**Federal Aviation  
Administration**

# **Optimization of Airspace and Procedures in the Metroplex (OAPM)**

## **Design Submission Executive Summary North Texas Metroplex**

Name of Change and Airport/s	Date
AKUNA, BLECO, GRABE and LOWGN–DFW	22 August 2013
Change Classification	Current Phase of Design
Terminal Procedure SID	<input type="checkbox"/> Preliminary Design (PD) <input type="checkbox"/> Operational Design (OD) <input type="checkbox"/> Operational Design Complete (ODC) <input type="checkbox"/> Proposed Final Design (PFD) <input checked="" type="checkbox"/> Final Design (FD)
OAPM Study Team Reference(s)	Publication Date
Solution 11	29 May 2014
Affected Airport(s), Facilities and Positions, Areas, and/or Sectors	Facility Points of Contact
<b>Fort Worth ARTCC (ZFW)</b> <ul style="list-style-type: none"> <li>• Sector 53</li> </ul> <b>Dallas Fort-Worth TRACON (D10)</b> <ul style="list-style-type: none"> <li>• Sectors AR7, DN, DR1, DR2, DR3, DS, MN and MNH</li> </ul>	<b>ZFW</b> <ul style="list-style-type: none"> <li>• Robert Ellis</li> <li>• Jon Shedden</li> </ul> <b>D10</b> <ul style="list-style-type: none"> <li>• James Harlan</li> <li>• Ed Rivas</li> </ul>

**Figure 3. Proposed BACHR RNAV STAR and KNEAD STAR**

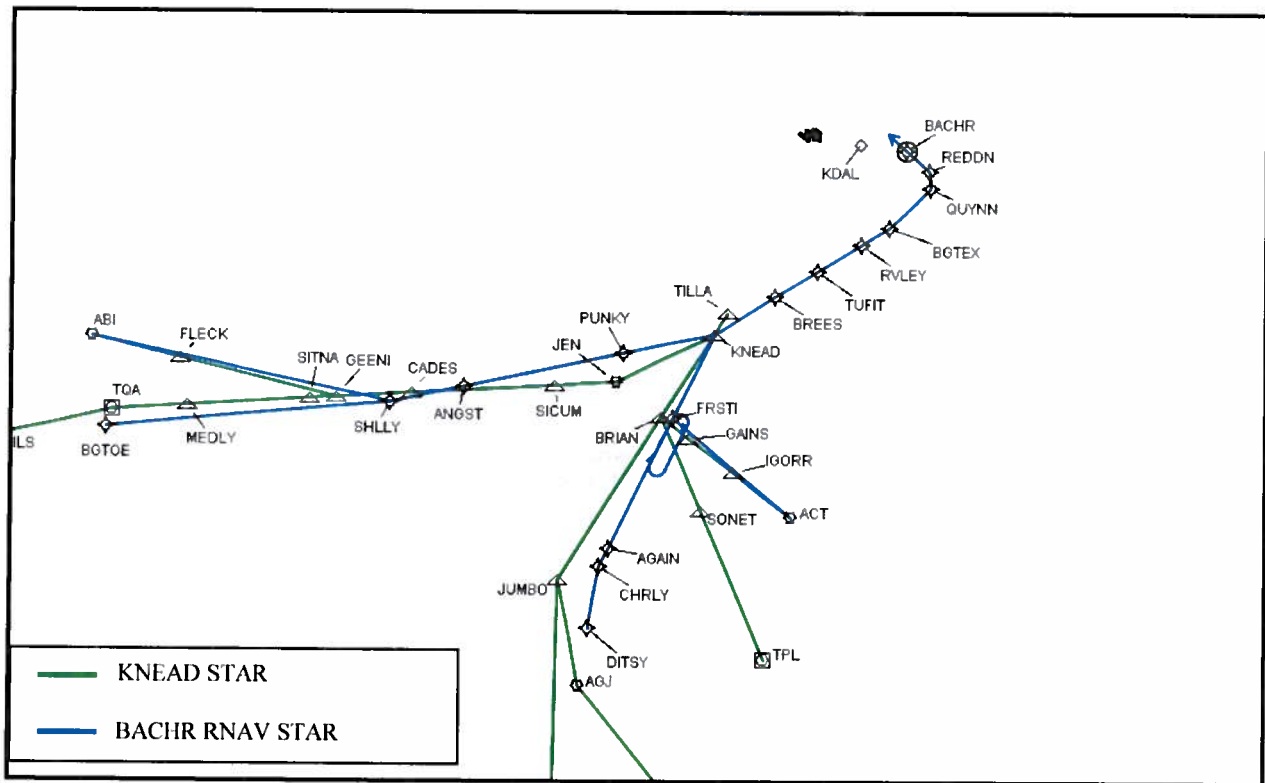
Figure 3 depicts the proposed BACHR RNAV STAR.

**Figure 4. Proposed NRTAY RNAV STAR and KNEAD STAR**

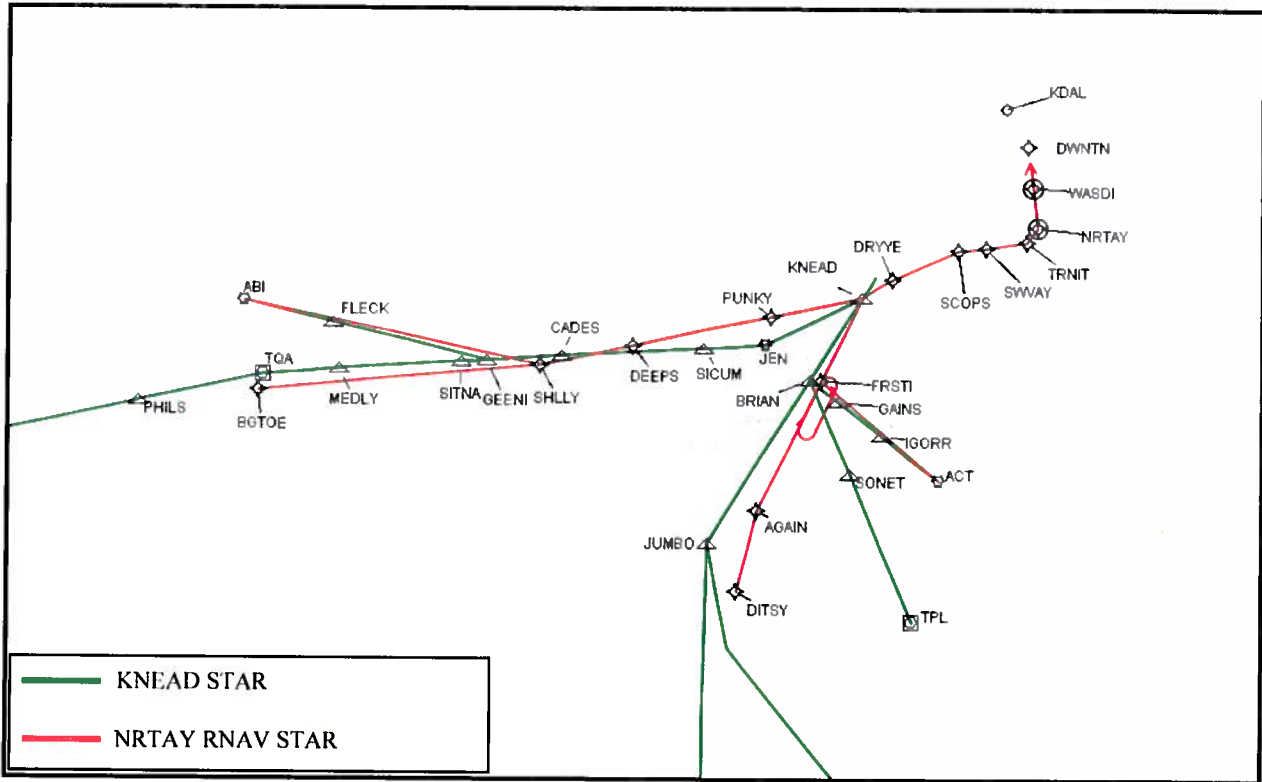
Figure 4 depicts the proposed NRTAY RNAV STAR.

**Figure 2. Proposed REDDN RNAV STAR and DUMPY STAR**

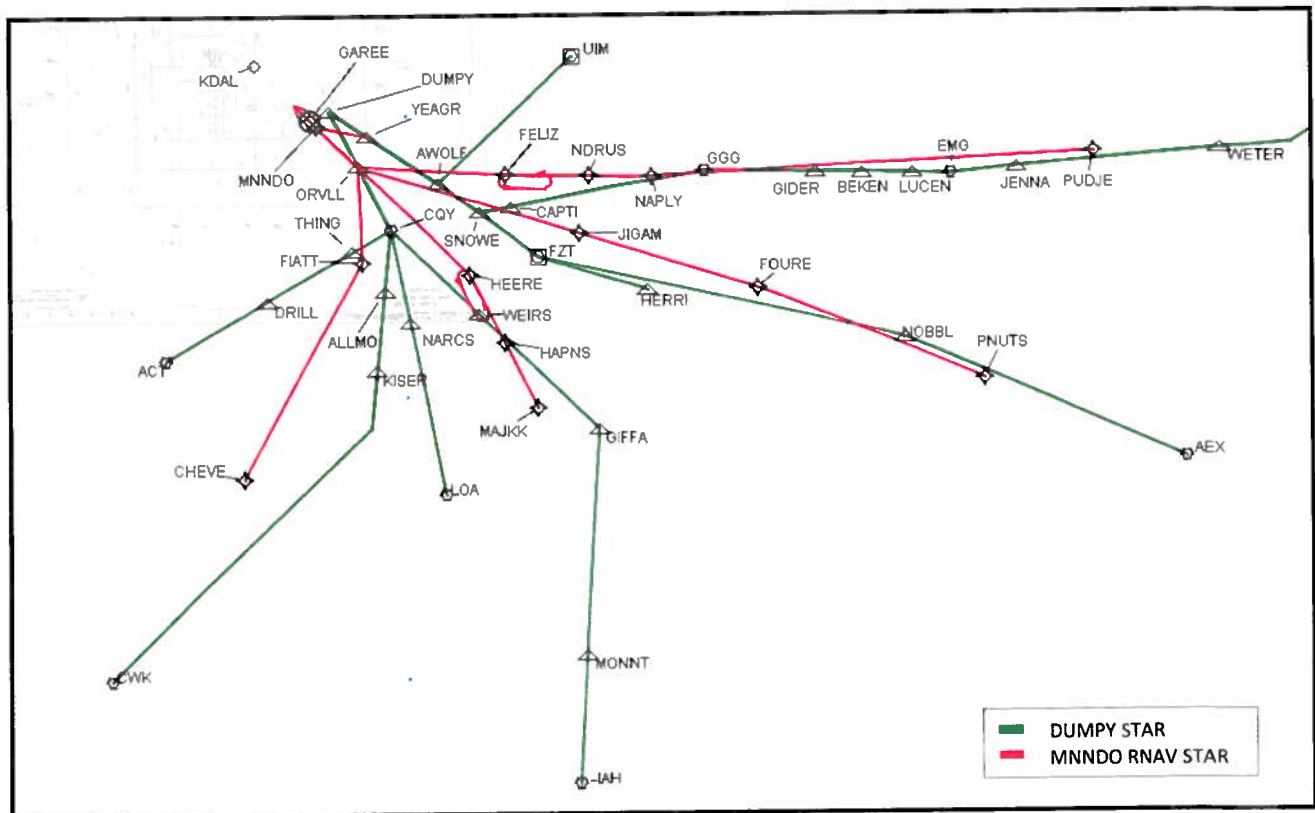
The Design Team is proposing the creation of two new RNAV STARs, named MNND0 and REDDN. Both MNND0 and REDDN RNAV STARs will be Optimized Profile Descents (OPDs). The proposed RNAV STARs will segregate the flow of traffic over the Southeast Corner Post in north and south flow eliminating the need to sequence a merge of traffic over the DUMPY waypoint. The MNND0 RNAV STAR incorporates runway transitions to Runway (RWY) 31 Left (L) and Right (R). This procedure terminates in an FM leg associated with the proposed Required Navigation Performance-Authorization Required (RNP-AR) procedure or aircraft will receive vectors for sequencing. The MNND0 RNAV STAR is procedurally de-conflicted from the YEAGR RNAV STAR, except when ATC assigns DAL arrivals the transition over YEAGR. This will be done on a non-interference basis with east satellite arrivals.

These proposed procedures are slightly modified from the Study Team recommendation to enhance traffic metering, reduce controller task complexity, increase flight path predictability and reduce miles flown.

Figure 2 depicts the proposed REDDN RNAV STAR

**Figure 3. Proposed NANDR RNAV STAR and GREGS STAR**

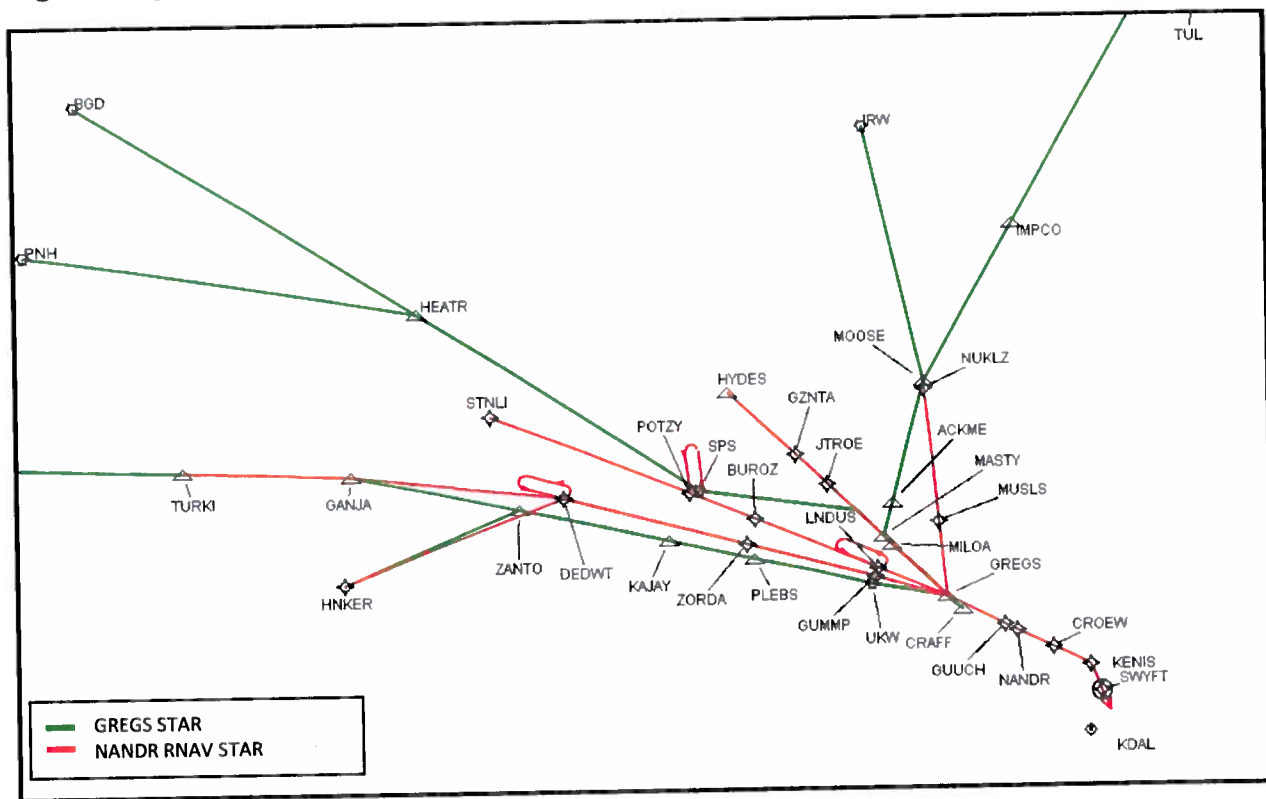
The North Texas OAPM Design Team is proposing the implementation of the NANDR RNAV STAR to DAL, as an alternative to the Study Team's recommendation to implement the MOTZA RNAV STAR. After extensive examination and analysis of the Study Team's MOTZA RNAV STAR recommendation the Design Team concluded it was not procedurally feasible to implement it for DAL in a north or south flow. The proposed NANDR RNAV STAR will have five enroute transitions that merge over GREGS waypoint. In a north flow, arrivals on the NANDR RNAV STAR continue southeast bound after GREGS to SWYFT waypoint providing several shortcuts over the current GREGS STAR. In south flow, arrivals will fly the JFRYE RNAV STAR.

The Design Team's proposal will segregate the DFW and DAL arrival turbojets and procedurally de-conflict the DAL turbojets from the DFW Primary and Dual routes over the Northwest Corner

Figure 3 depicts the proposed NANDR RNAV STAR.

**Figure 3. REEKO RNAV STAR and DODJE STAR**

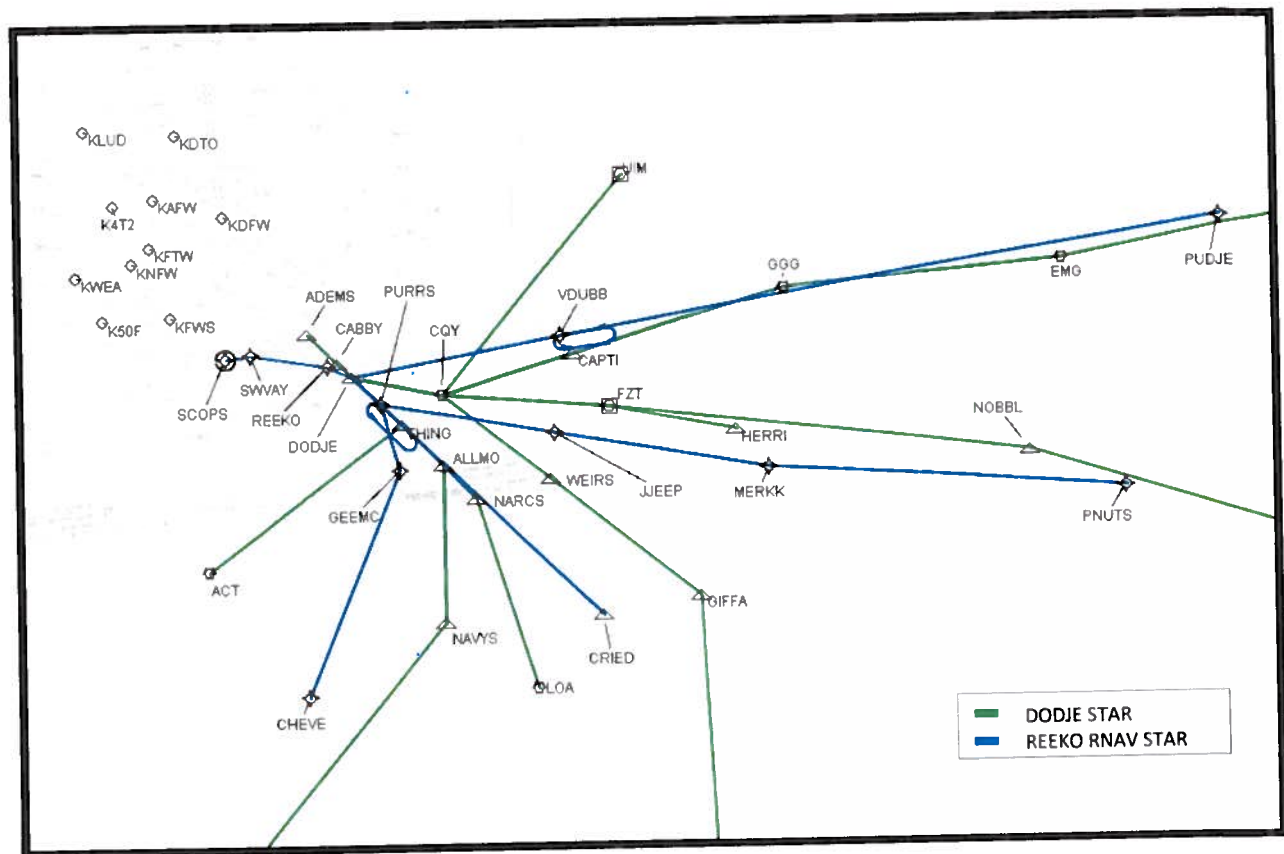
Figure 3 depicts the proposed REEKO RNAV STAR.

**Figure 2. Proposed JFRYE RNAV STAR and GREGS STAR**

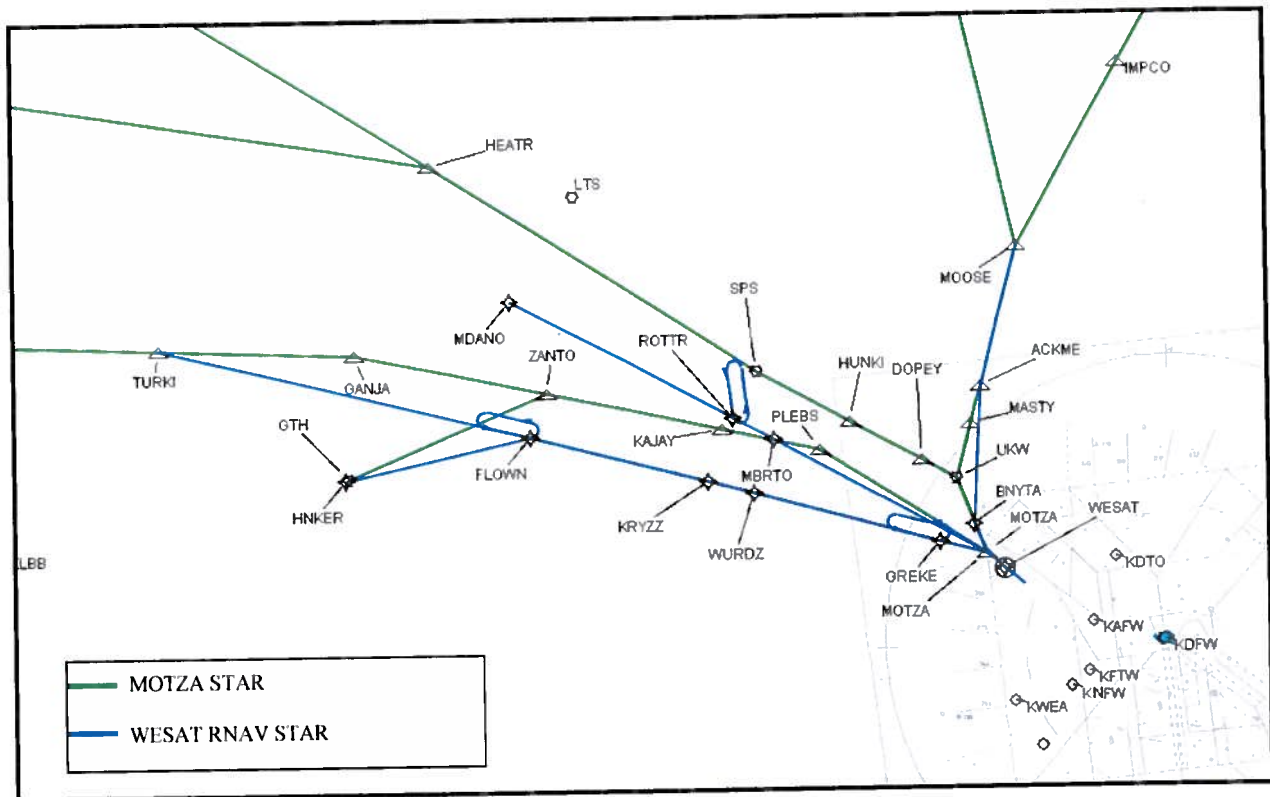
Figure 2 depicts the proposed JFRYE RNAV STAR.

**Figure 2. Proposed SWVAY RNAV STAR and KNEAD STAR**

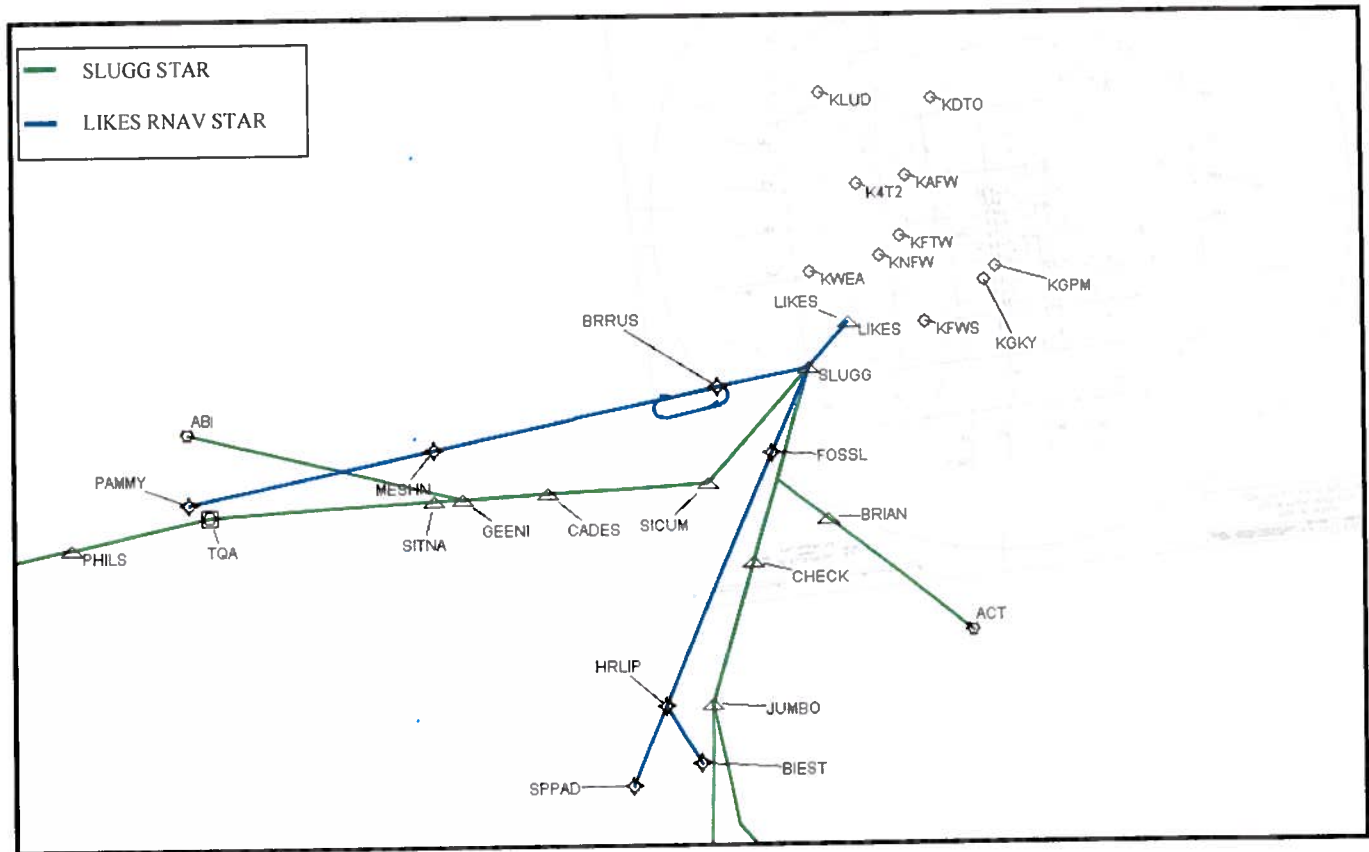
The Design Team's proposal will procedurally de-conflict the DFW Dual route traffic and DAL arrivals over KNEAD waypoint from the East Satellite arrivals in a south flow. In a north flow East Satellites and DAL arrivals over KNEAD will follow the same route. This route closely follows the current route that East Satellite arrivals are frequently vectored to when arriving over KNEAD in north and south flows. ACT TRACON and GRK RAPCON departures will be routed over FRSTI waypoint. ABI and SJT TRACON departures will go over SHLLY waypoint.

Figure 2 depicts the proposed SWAVY RNAV STAR.

**Figure 2. Proposed SLANT RNAV STAR and FINGR STAR**

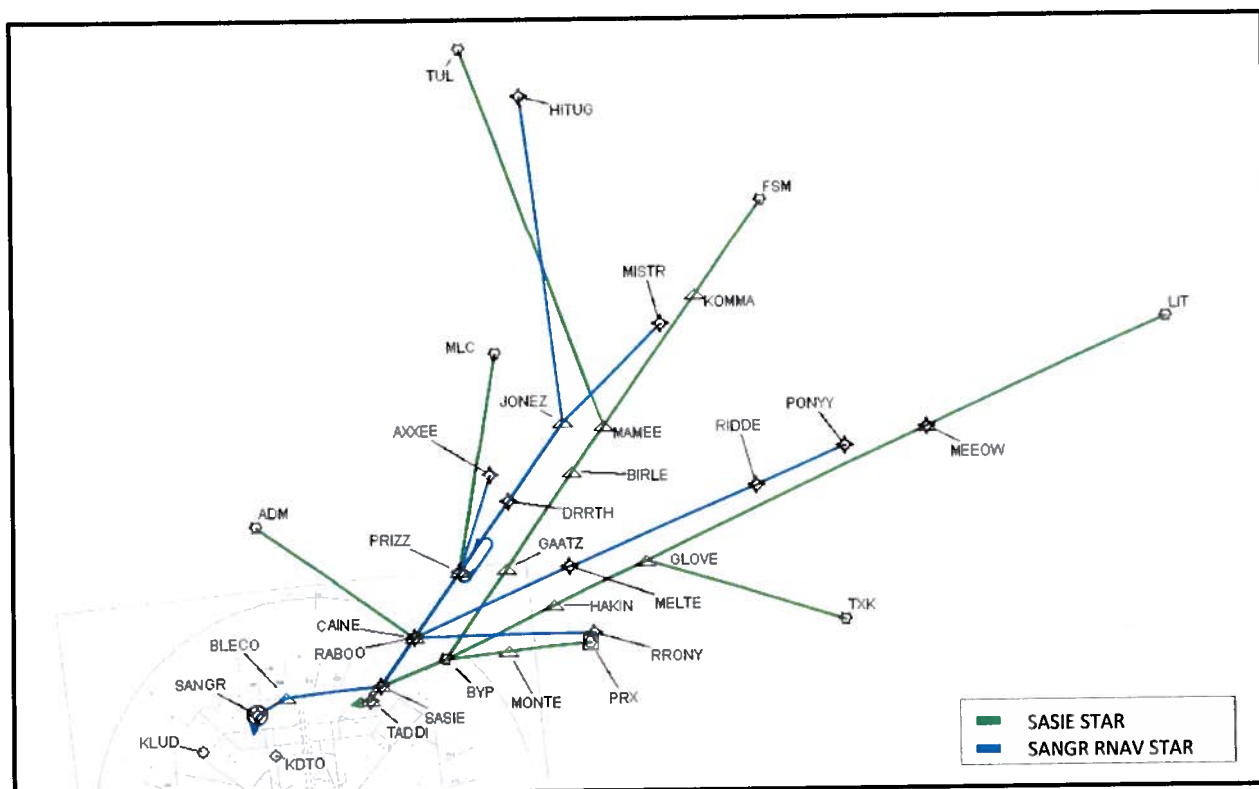
Figure 2 depicts the proposed SLANT RNAV STAR.

**Figure 2. Proposed RNP-AR to RWY31L/R**

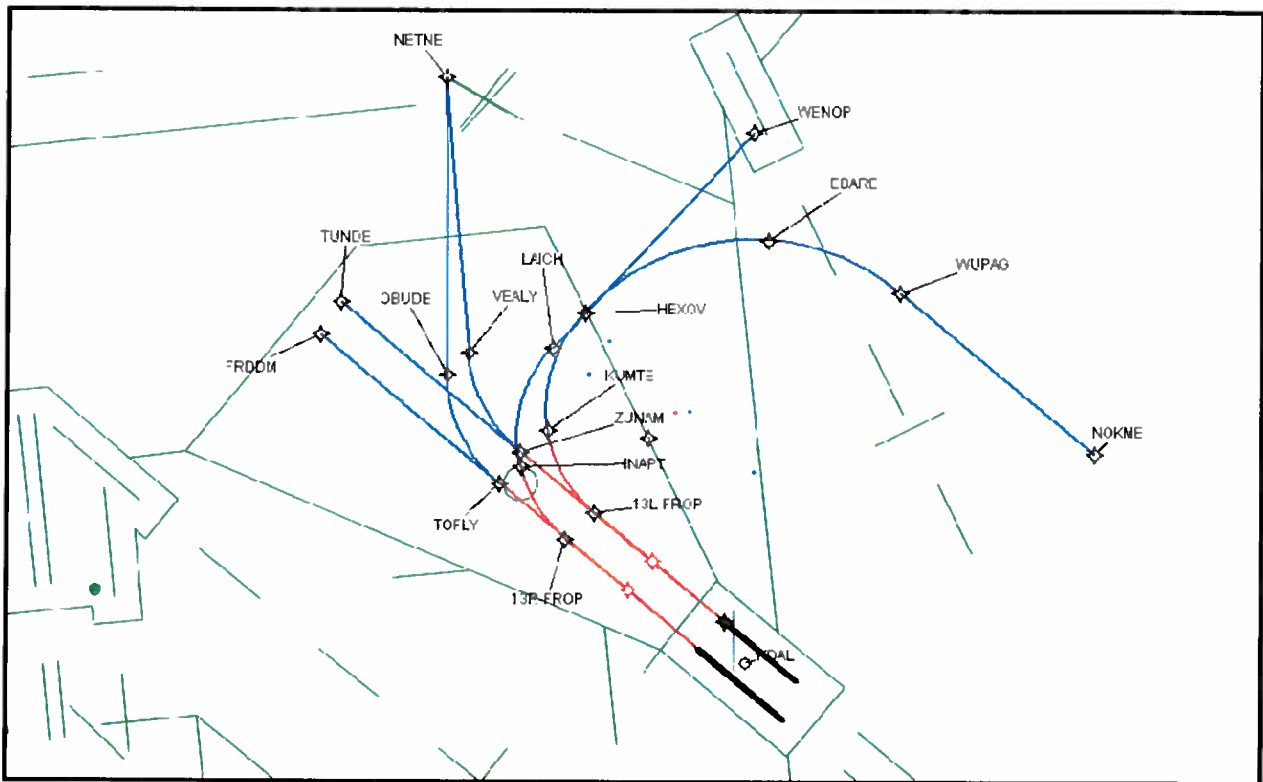
The North Texas OAPM Design Team is proposing the implementation of four RNP-AR approach procedures to DAL Runway 31 Left (L), RWY31 Right (R), RWY13L and RWY13R. The procedures will tie directly into the BACHR, HIBIL, MNND0, NANDR, NRTAY, REDDN and TRYST RNAV STARs. They will overlay the current visual arrival paths and will be an option during Instrument Meteorological Conditions (IMC). These proposed procedures will reduce controller and pilot task complexity and increases flight path predictability.

Figure 2 depicts the proposed RNP-AR Approach to Runway 31L/R.
